Update the text in 135.5.7.2 as follows...

135.5.7.2 Precoding for PAM4 encoded lanes

Figure 135-x: Example precoder variable locations for a PHY with 50GAUI-1

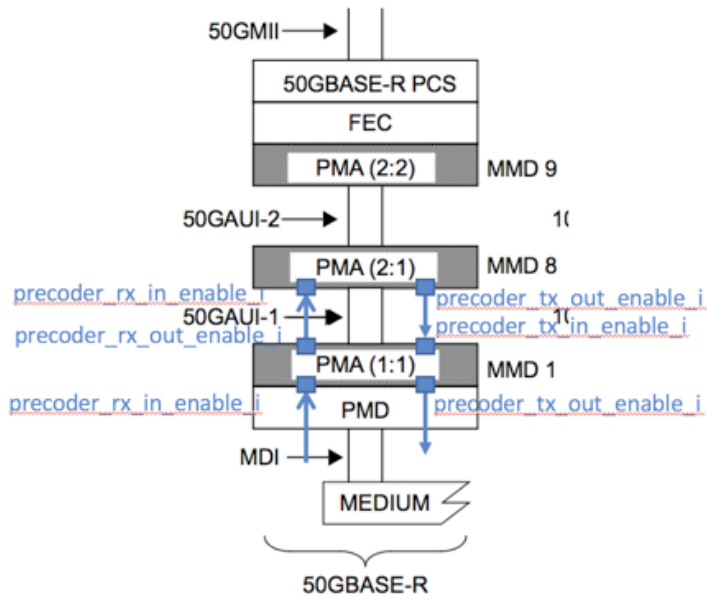
Add the following diagrams to 135.5.7.2
